[Docket No. FAA-2023-2435; Special Conditions No. 25-862-SC]

Special Conditions: Gulfstream Aerospace Corporation Model GVIII-G700 and GVIII-G800 Series Airplanes; Dynamic Test Requirements for Single- and Multiple-Occupant Side-Facing Seats With or Without Airbag Systems

AGENCY: Federal Aviation Administration (FAA), DOT.
ACTION: Final special conditions.

Figure 2

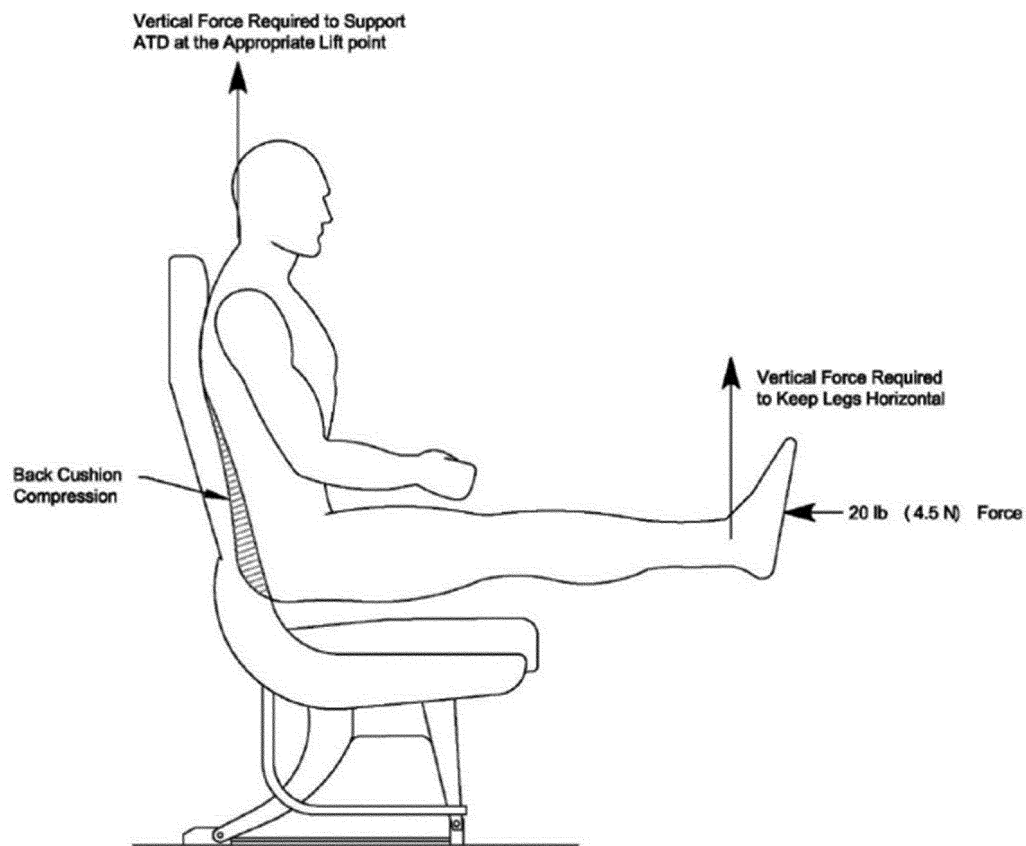
2. The commenter stated that the proposed special conditions paragraph 1.e(1)(b) may cause confusion, in that the word "bottom" is singular and the word "feet" is plural. This wording, according to the commenter, could lead to an interpretation that the force of about 20 pounds (lbs) may be applied to each foot, plus it is not specified that the force be applied uniformly. The commenter also suggested a specific revision to the text of this paragraph to address these concerns. The FAA disagrees that there is ambiguity or that a change is necessary. The 20 lbs of force is the total force applied to the bottom of the feet. The text of the special condition is similar to the language of FAA Policy Statement PS-ANM-25-03-R1 "Technical Criteria for Approving Side-Facing Seats." No changes were made to these special conditions as a result of this comment.

Lower the ATD vertically into the seat while simultaneously (see Figure 2 for illustration):

(b) Applying a horizontal x-axis direction (in the ATD coordinate system) force of about 20 pounds (lbs) (89 Newtons [N]) to the bottom of the feet of the ATD with the legs straight, to compress the seat back cushion.

Figure 3

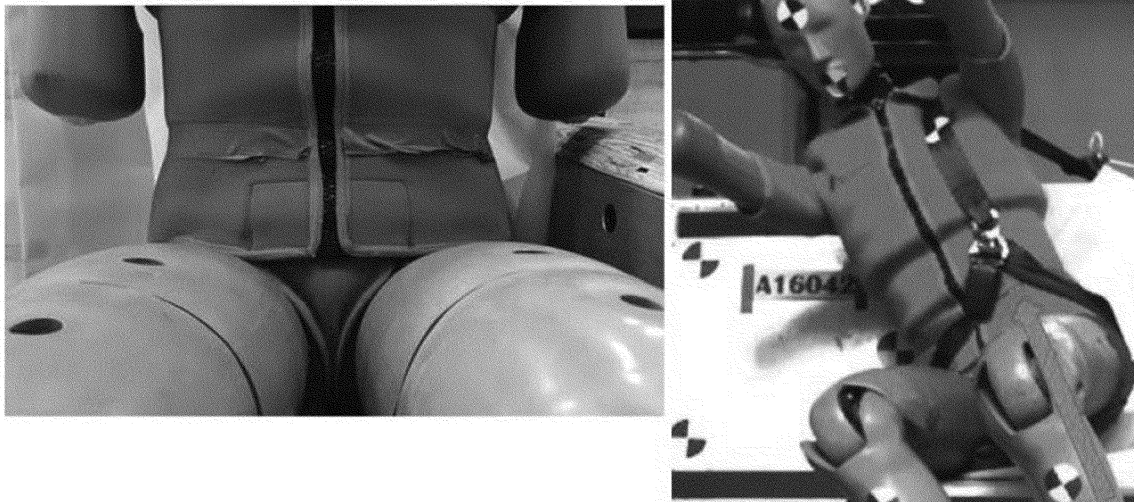
content of paragraph 2.g. of the special conditions. The commenter suggested adding a colon at the end of paragraph g., and that subsequent special conditions should be numbered below that paragraph. The commenter also stated that paragraph 2.g. does not explicitly state when lap belt tension must be limited to 250 lbs, and that the rationale for the limit in the Civil Aerospace Medical Institute (CAMI) report does not have to be specified in the proposed special conditions. The commenter further stated that paragraph 2.g. has a typographical error in that data should be filtered at "CFC 600" as defined in SAE JS211-1 "Surface Vehicle Recommended Practice." The FAA agrees with most of the comments received on paragraph 2.g. The FAA has revised the formatting of paragraph 2.g. to reflect the requirements clearly. The FAA does not concur with the commenter that the data should be filtered at CFC 600 versus 60. Sixty is the correct value for belt loads in SAE JS211-1.

(1) A measurement of the belt loop load during the time when the belt moves above the pelvis (submarining) must not exceed 500 lbs (2,225 N) (*a 250 lb (112.5 N) lap belt tension limit*). Data must be filtered at CFC 60 as defined in SAE J211. To evaluate the pelvic restraint performance using this criterion, three things are needed:

(a) A clear indication of when the belt moves above the pelvis. Loose clothing can make it difficult to determine where the top of the pelvis is, and in turn make it hard to discern exactly when the belt moved above it. This can be improved by marking the top of the pelvis clearly and by positioning the cameras so that

the position of the belt, relative to the top of the pelvis can be observed throughout the test (see Figure 3).
